SITE DEVELOPMENT PLANS FOR

LOT 14 PARKER POINTE PARKER, COLORADO 80134

Ziggis
COFFEE
PARKER, COLORADO

PLANTING PLAN

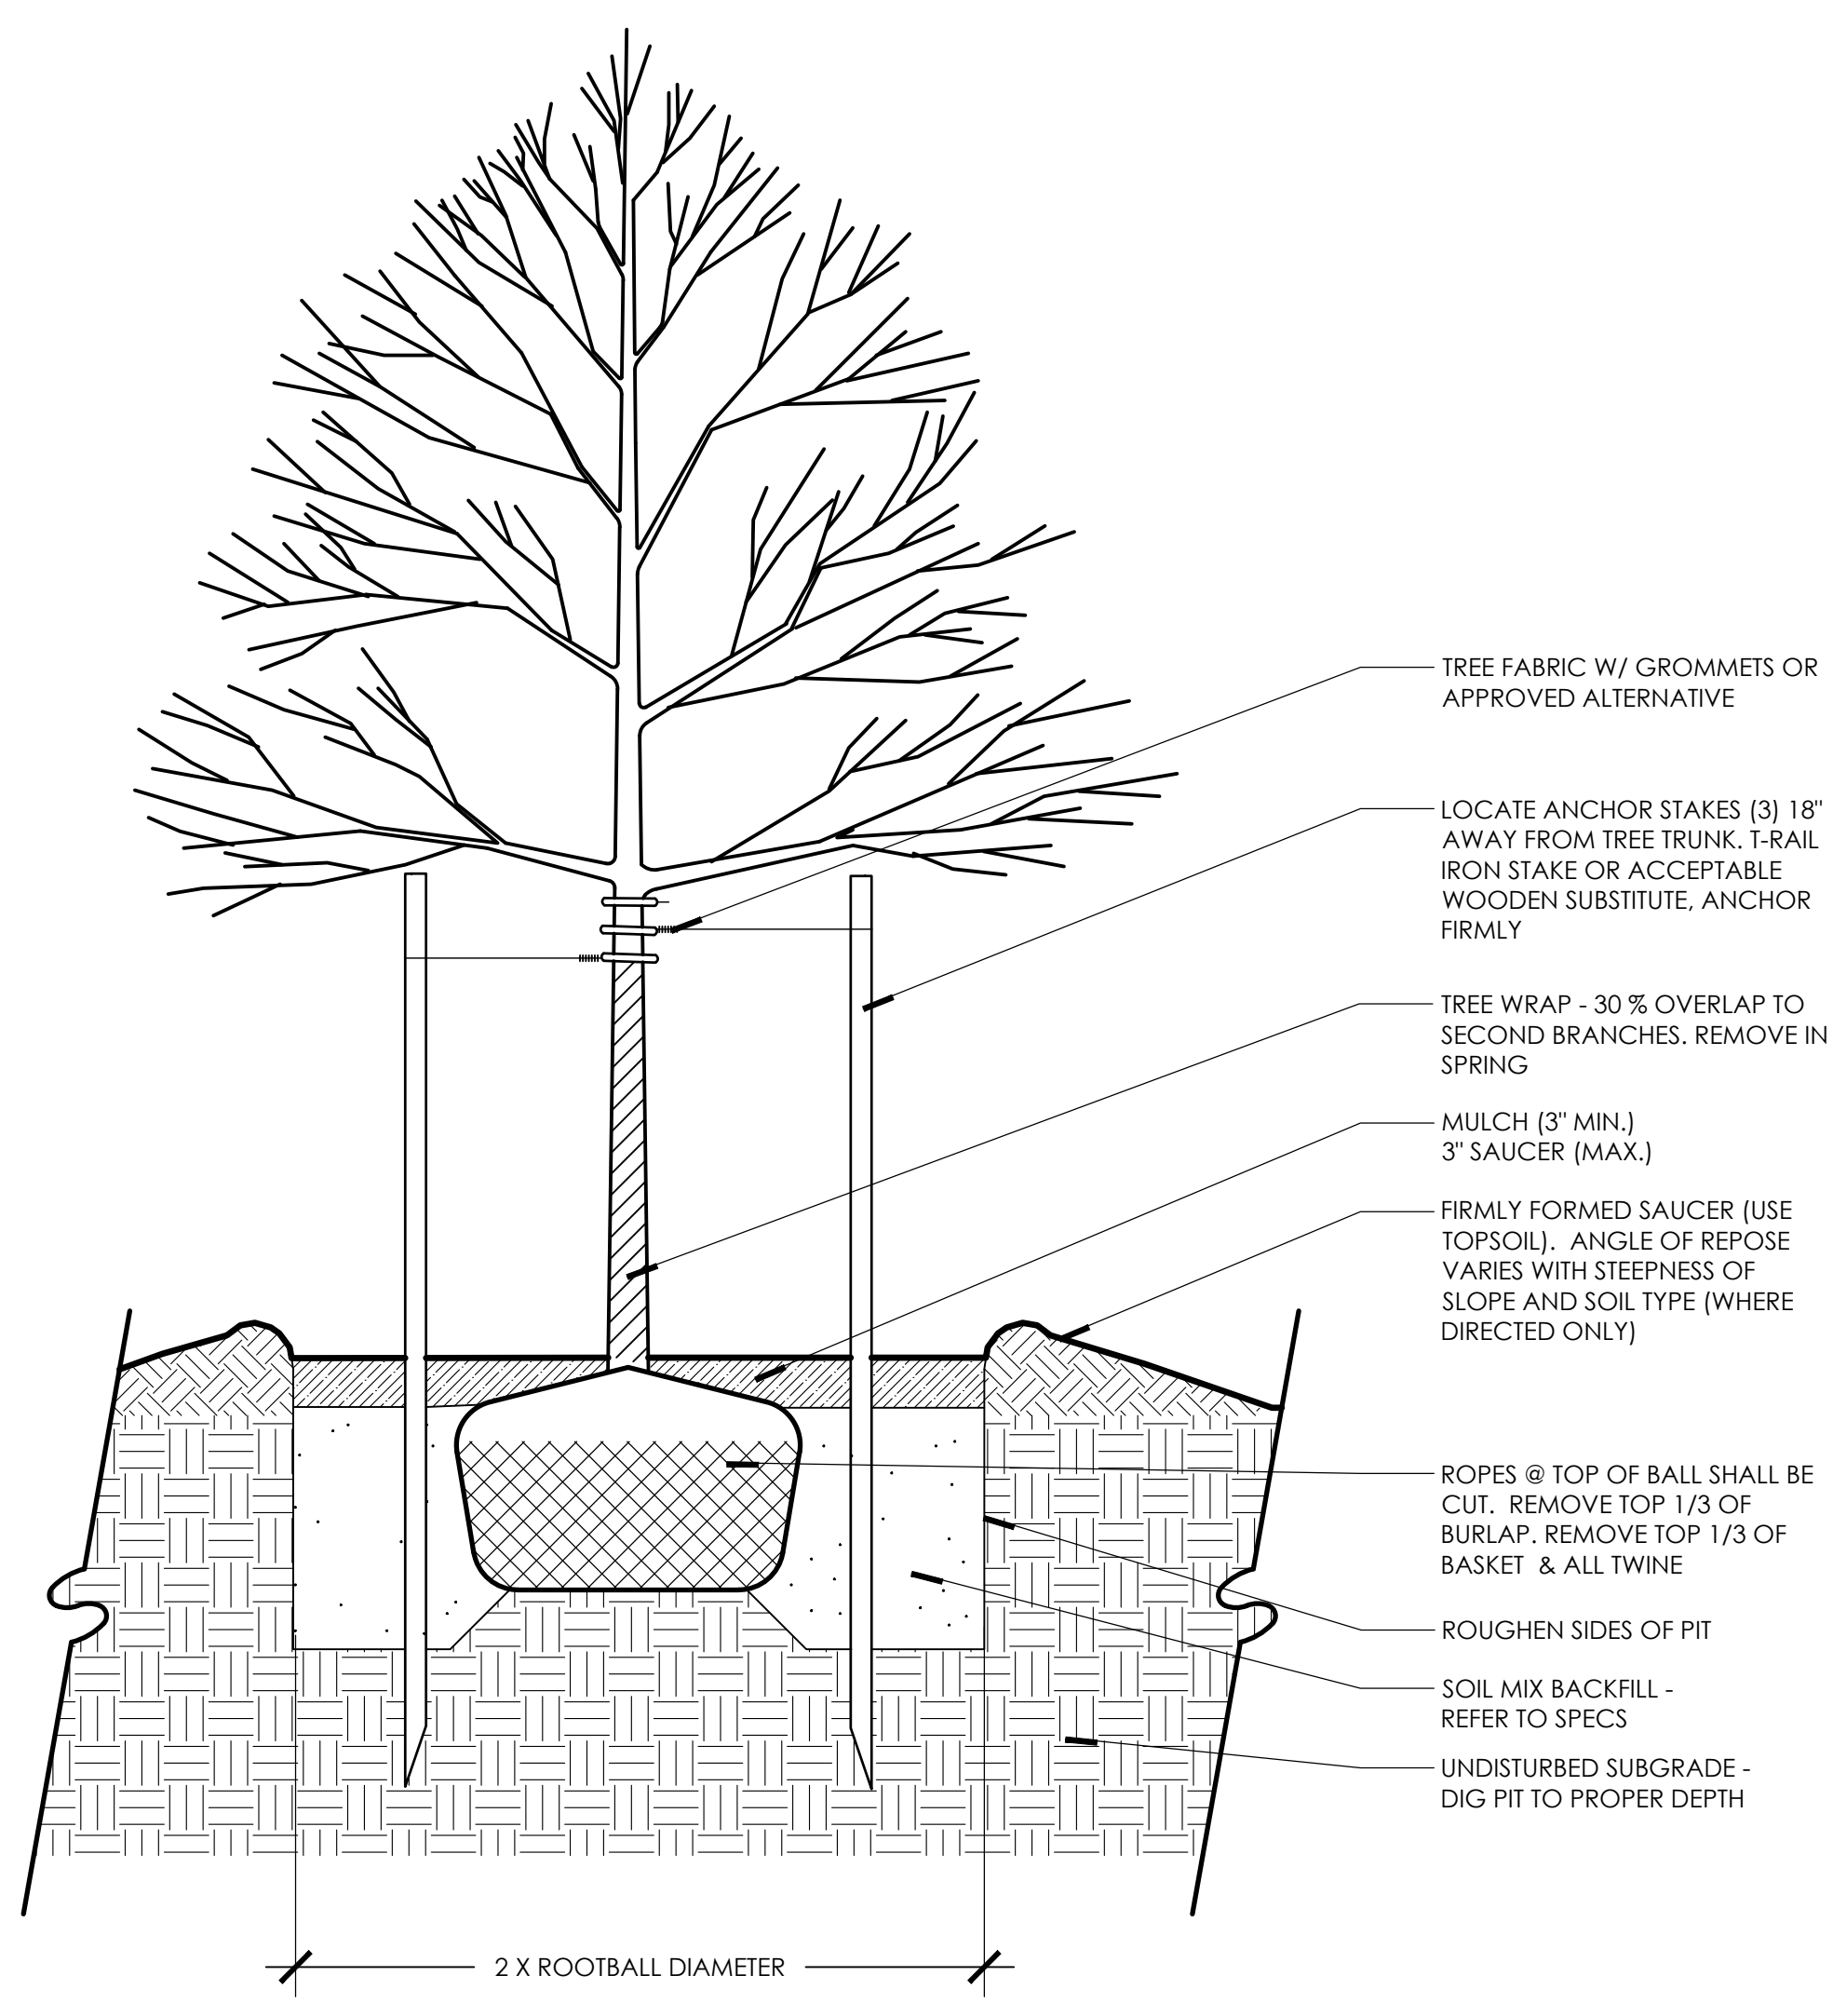
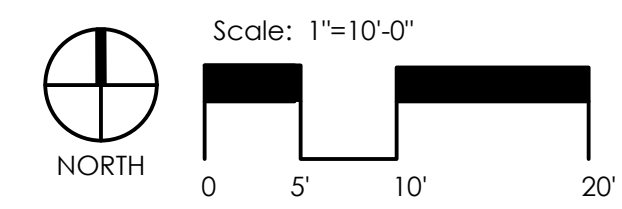
Please consider the use of an approved Native Seed rather than buffalo grass.

Buffalo grass is not appropriate in internal landscape area and has been historically difficult to establish. Even when established, which takes 2-3 years, it doesn't have a landscaped appearance. Additional trees or shrubs could be added that would be more aesthetically pleasing for drivers waiting in line.

Buffalo grass will not be accepted adjacent to the sidewalk. Please consider a turf grass in this area provided the total turf does not exceed 15%.

There is not enough variation in variety to ensure the continued appeal of a project in those instances where a particular species is killed through insect or disease activity. 13.06.070 (g) (3)

Please add a note stating that any changes to the landscape plan requires prior approval from the Town.

Please provide justification, there appears to be enough room to accommodate the required number of trees.

SHEET NAME
ELECTRICAL PHOTOMETRIC PLAN
 SHEET NUMBER

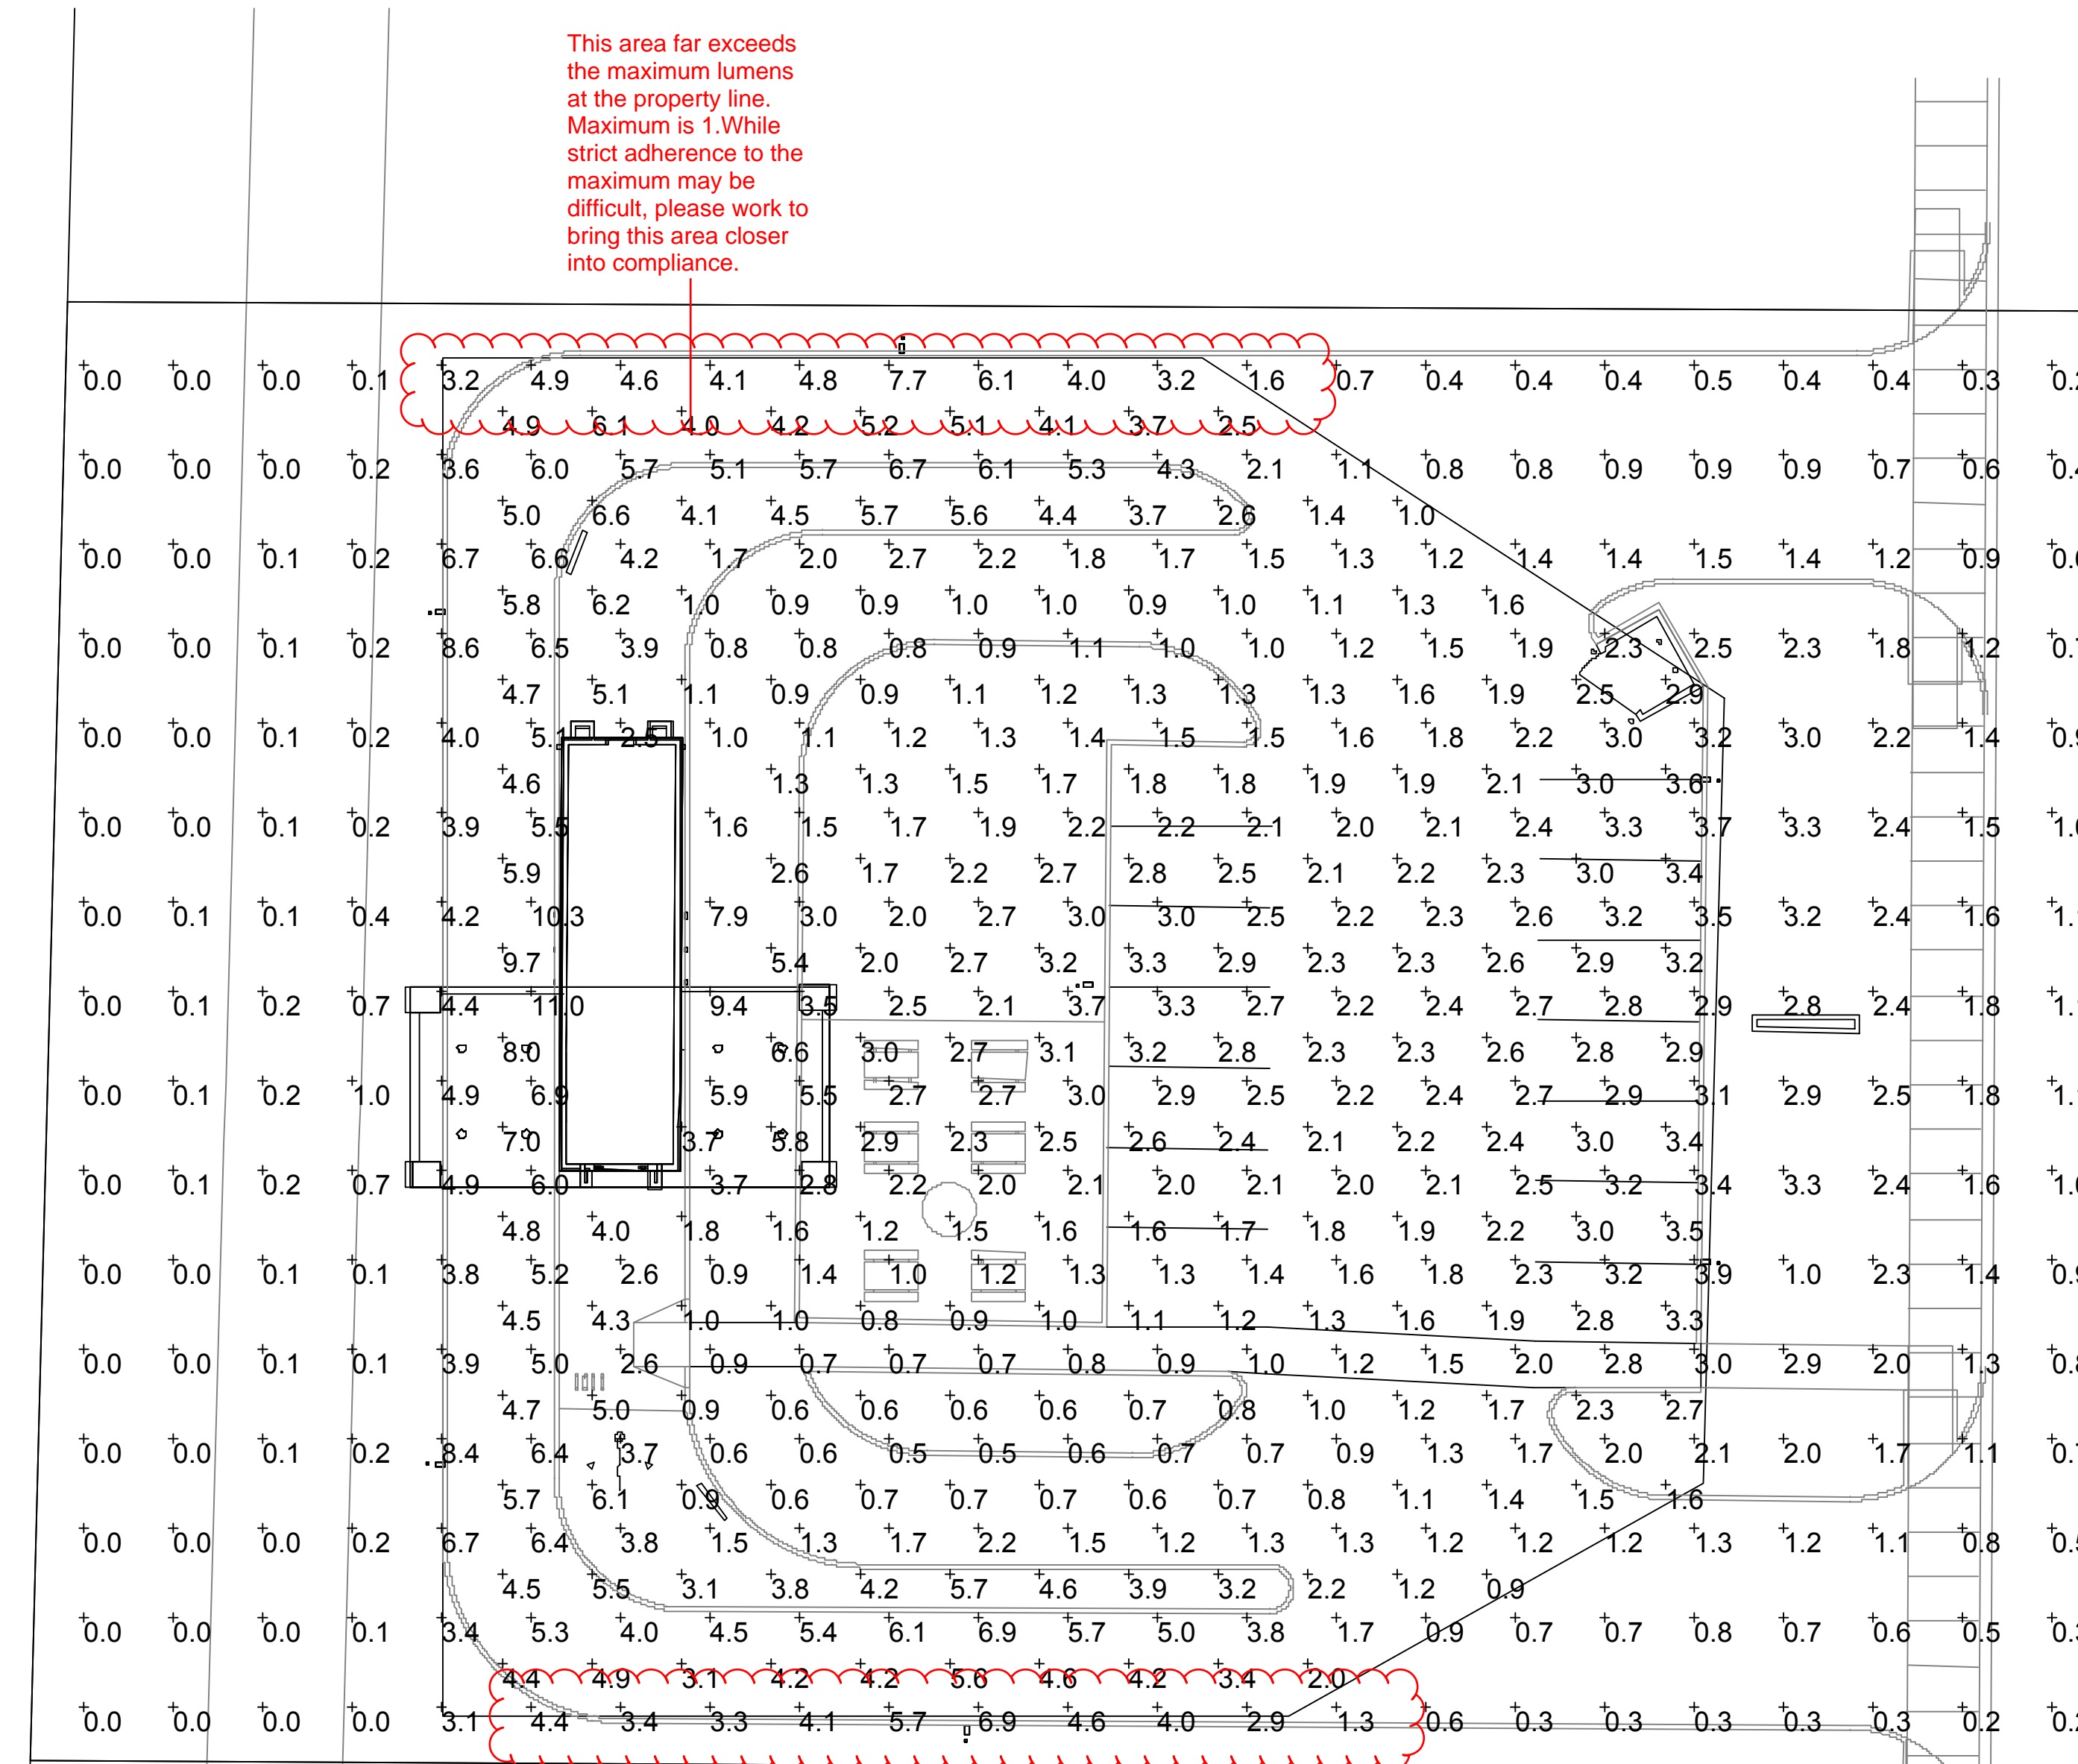
No lighting specs
 Fixtures are not shown on this photometric or on the elevations as required. If
 luminaires are being used, be sure to provide the height of the pole. All
 lighting is required to be fully shielded, please indicate that proposed lighting
 meets this requirement.
